SUBJECT: Mahaska County Sanitary Landfill, Binns & Stevens MSWLF Unit - 62-SDP-01-74P - Response to DNR Comments Regarding the 2025 AWQR TRANSMITTAL ID: 00001

Subject: Response to DNR Comments Regarding the 2025 AWQR
Mahaska County Sanitary Landfill
Binns & Stevens MSWLF Unit
Permit No. 62-SDP-01-74P

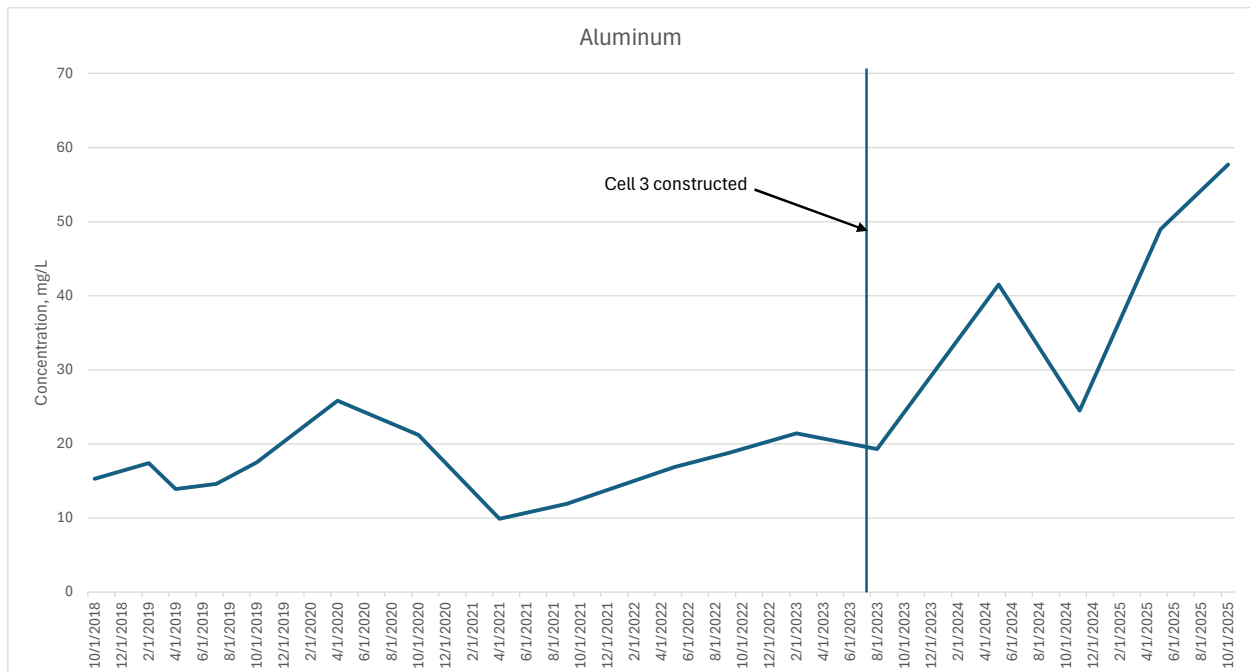
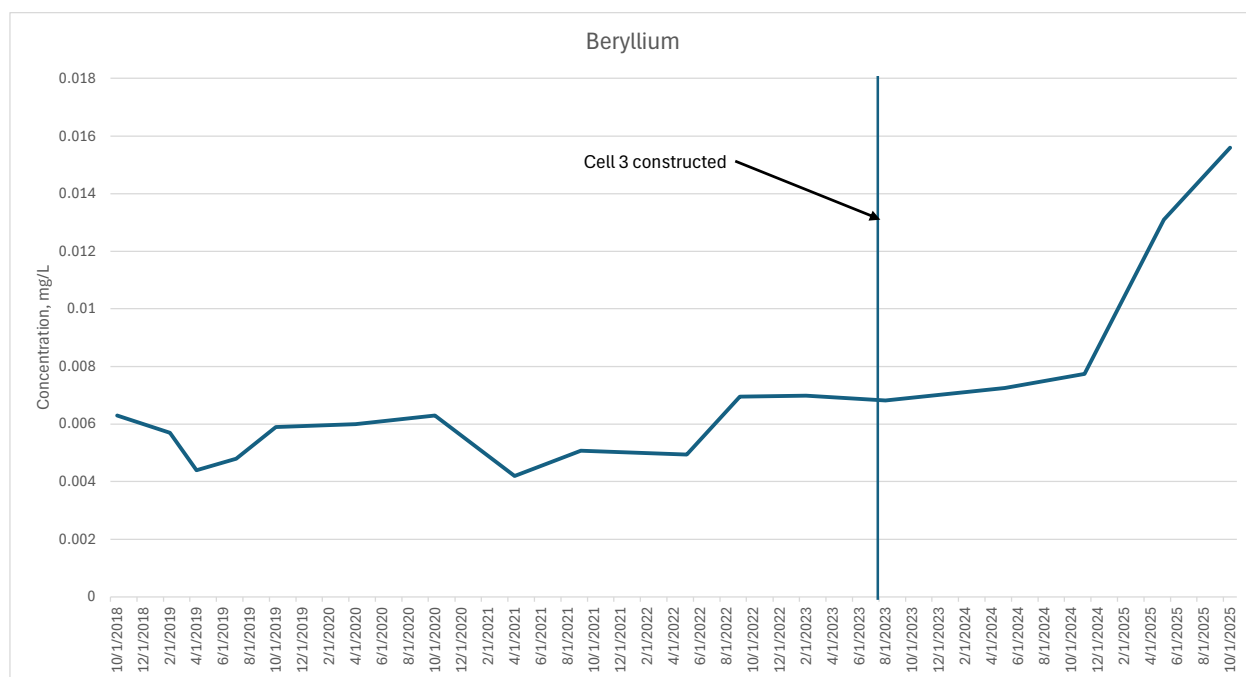
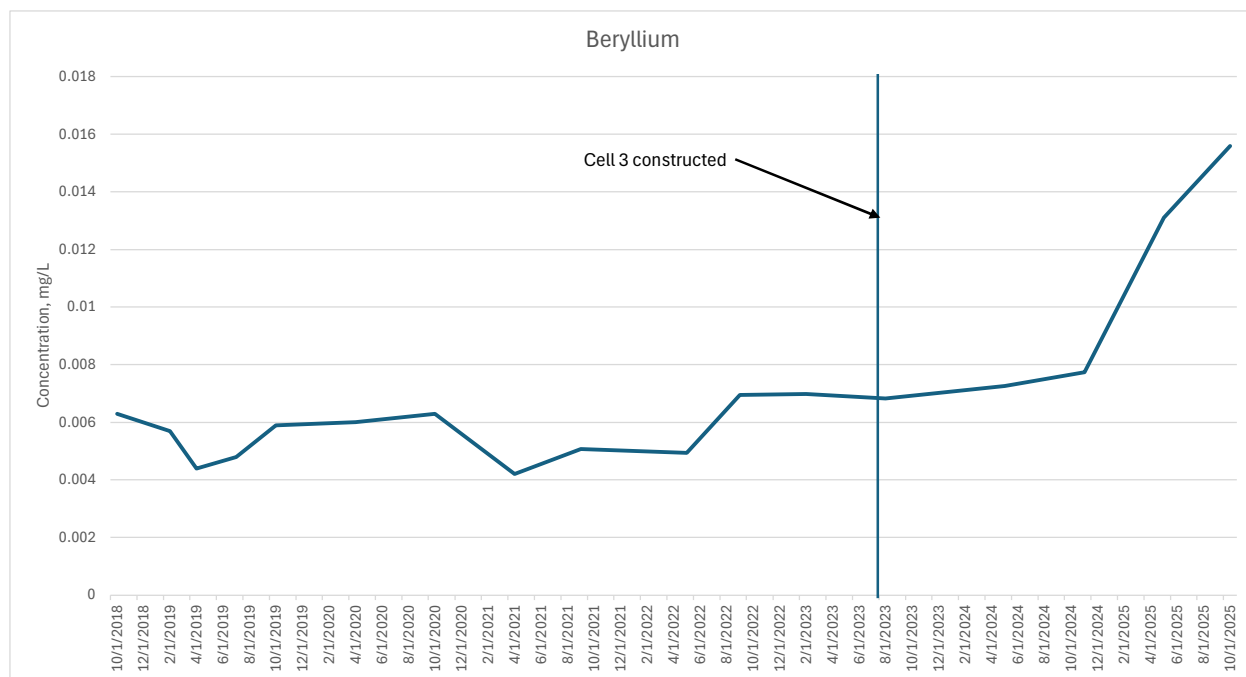
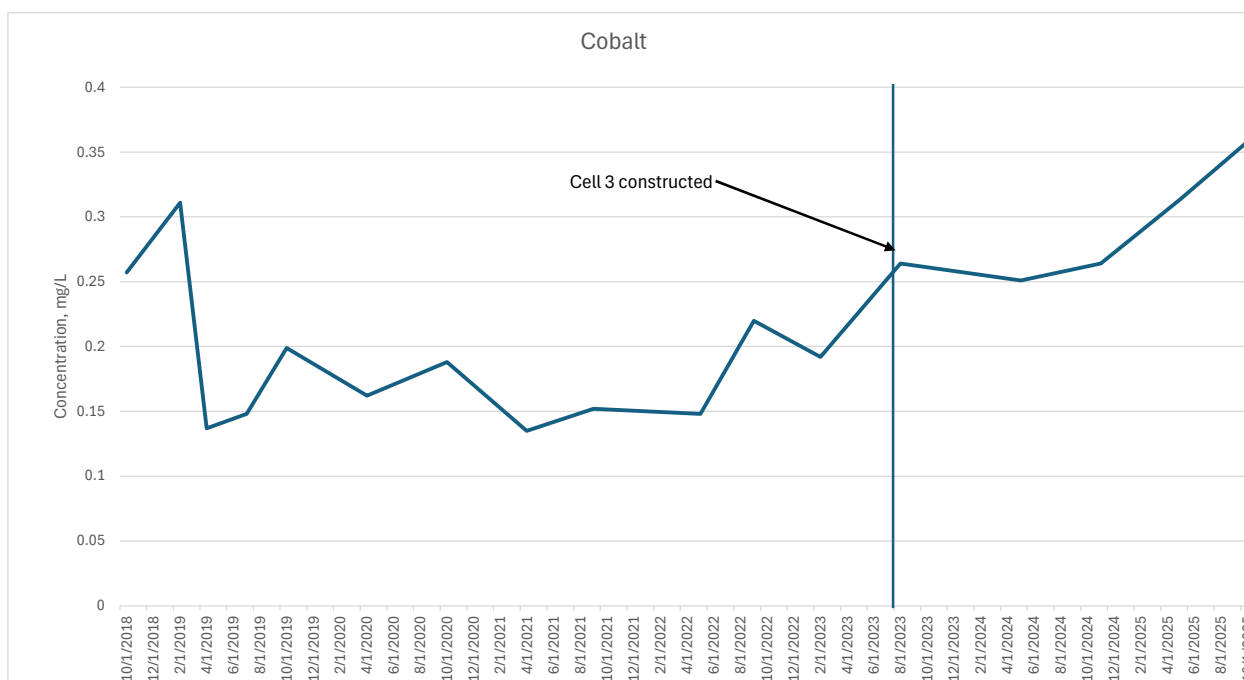
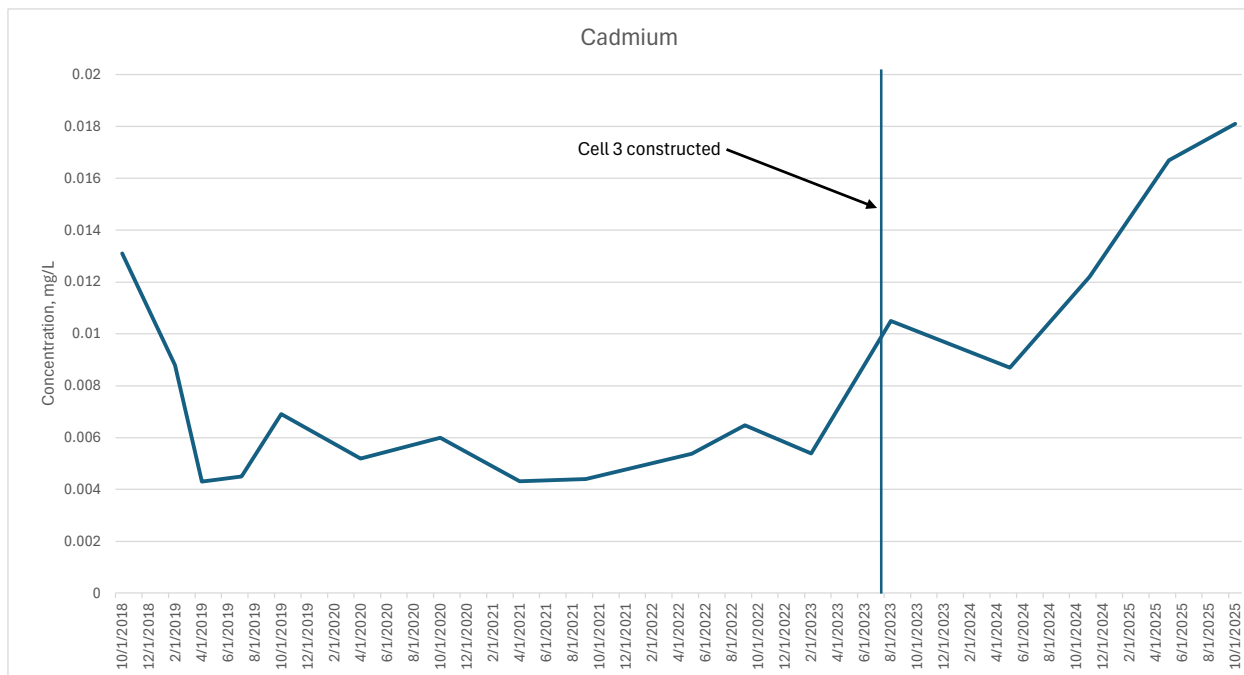
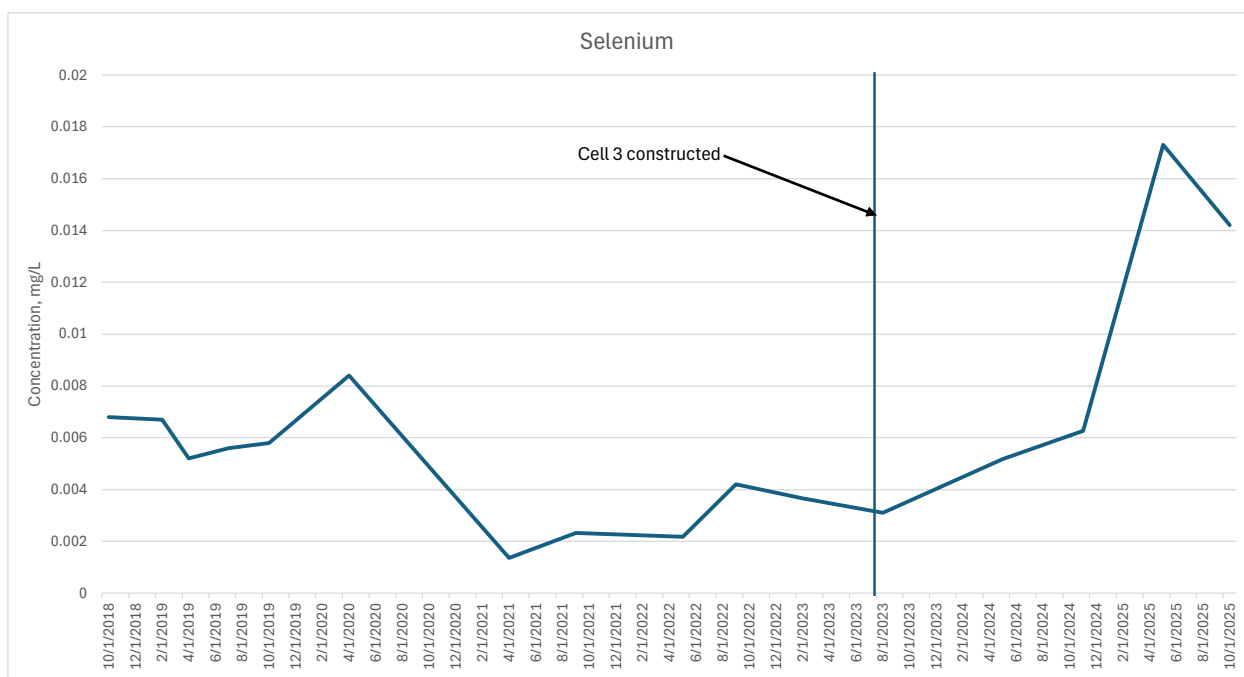
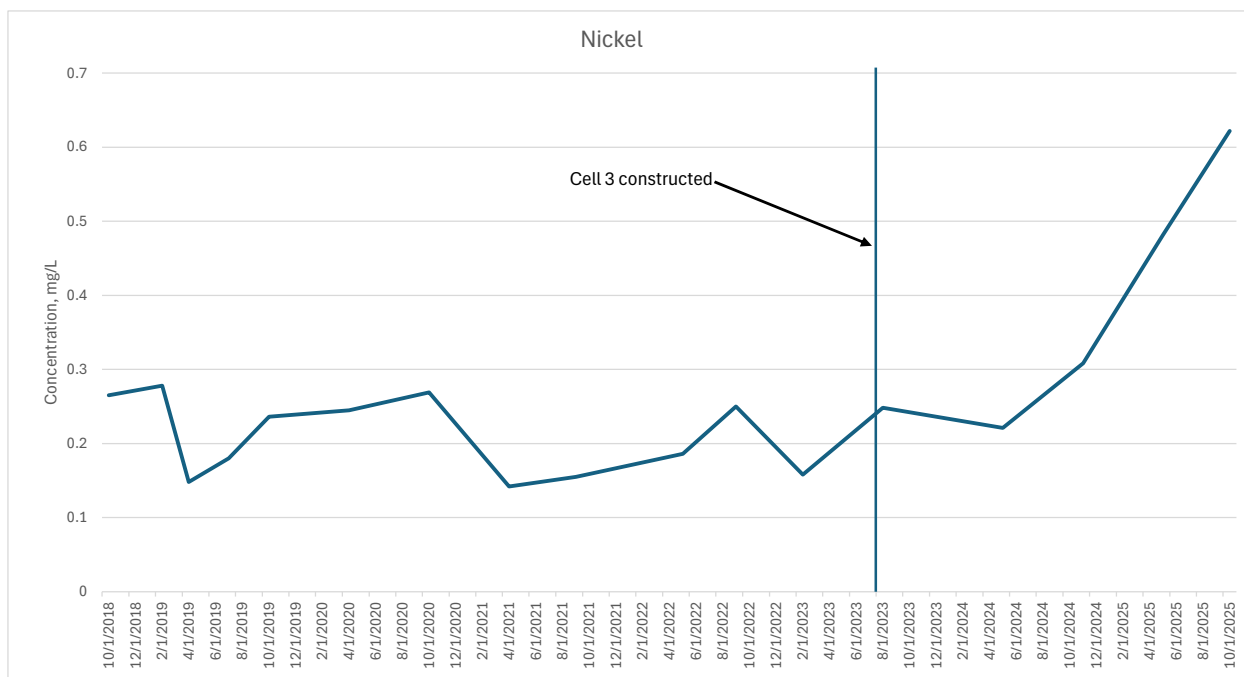
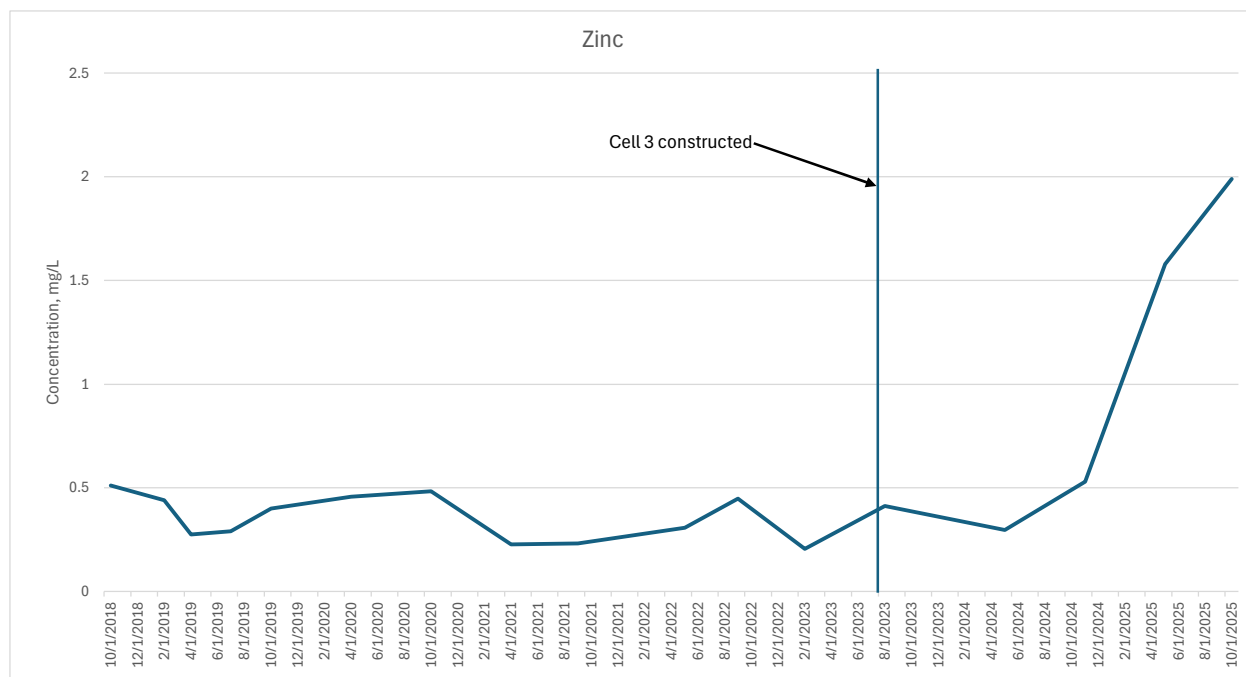
The DNR requires an evaluation of the chemical reasons for the increase in cadmium levels at monitoring well DW-24 before the DNR accepts the assertion that the increase in cadmium is the result of acid mine drainage and not the landfill.

Review of the time series plots showed marked increases in measured concentrations of aluminum, beryllium, cadmium, cobalt, nickel, selenium, and zinc in monitoring well DW-24 following the construction of Cell 3 in 2023, which also correlated with generally decreasing pH levels. As discussed in the article *Geosynthetics and the Minimization of Contaminant Migration through Barrier Systems Beneath Solid Waste* (Rowe, 1998),

For each of the metals listed above, as shown in the graphs below, the concentration increases coincided with or shortly followed after cell construction, beginning with the August 2023 or 2024 samples.

The construction of Cell 3 would have further disturbed materials in the area of monitoring well DW-24, possibly causing a localized increase in acid mine effects, and would have eliminated surface water infiltration upgradient of DW-24, which previously would have potentially served to dilute acid mine drainage effects in the vicinity of monitoring well DW-24. The soil/rock disturbance, combined with significantly reduced surface water infiltration/dilution occurring post Cell 3 construction, is the likely cause (source) of the increased concentrations of metals measured in groundwater monitoring well DW-24. Some time-lag in the appearance of Cell 3 construction effects at monitoring well DW-24 is expected, as the effects of eliminating surface water infiltration and migration to DW-24 would not be immediate.

Given the lack of VOCs as noted above and the increases in some metal concentrations after cell construction in 2023, it is unlikely that a release from the B&S MSWLF unit is the source of the elevated metal concentrations, including cadmium. It appears that the physical change(s) caused by the construction of the landfill liner affected the groundwater chemistry. Continued monitoring is recommended to investigate this trend. It is recommended that the effect of the liner installation be identified as an alternative source, the indicated SSI for cadmium not be confirmed, and that monitoring well DW-24 continue in the detection monitoring program.
